PRODUCT / PROCESS CHANGE NOTIFICATION

PCN-000809

Date: MAY-04-2022

Semtech Corporation, 200 Flynn Road, Camarillo CA 93012

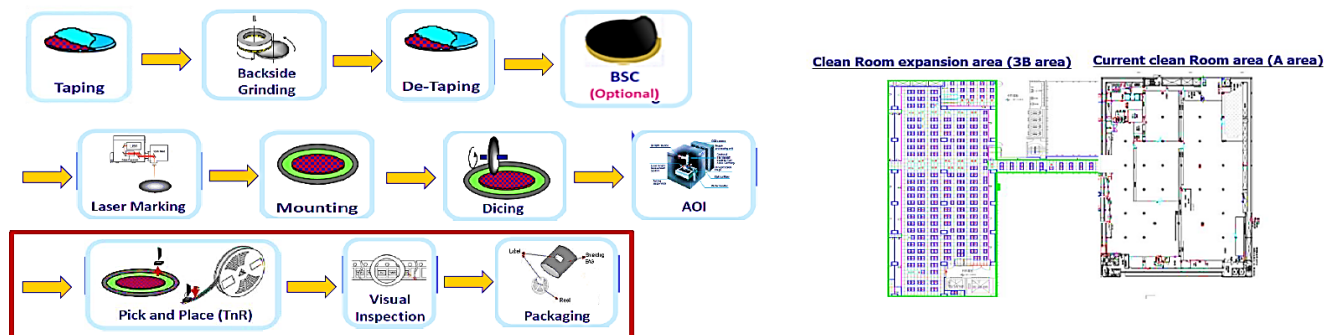
Chipbond, Semtech's supplier, is moving its current machines to a clean room expansion area adjacent to the current clean room area via a connector bridge. The clean room areas have their own central air conditioning, electricity, vacuum pump, and ESD ground, but the control specifications are the same and third-party certified.

As shown in the figure below, the impacted processes have been highlighted with a red box.

▪ Machine Information

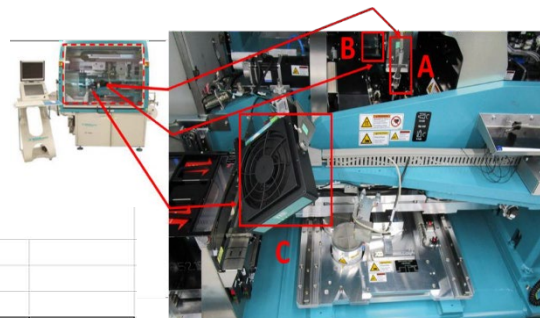
○ Pick and Place (TnR)

Machine	Mühlbauer DS-15000	Mühlbauer DS-20000

Die size range	0.5"0.5~7"7mm	0.5"0.5~7"7mm
Wafer size	6/8/12 inch	6/8/12 inch
Sprint UPH	About 12k	About 18k
Placement precision	X/Y Coordinate : ±30um, Theta: 2°	X/Y Coordinate : ±30um, Theta : 2°
Sealing Tape Force	Max =100N	Max =100N
Sealing Shoe Temperature	Room temperature to 220°C	Room temperature to 220°C
Sealing Shoe Temperature Precision	Target ±5 °C	Target ±5 °C
IR capability	No	No
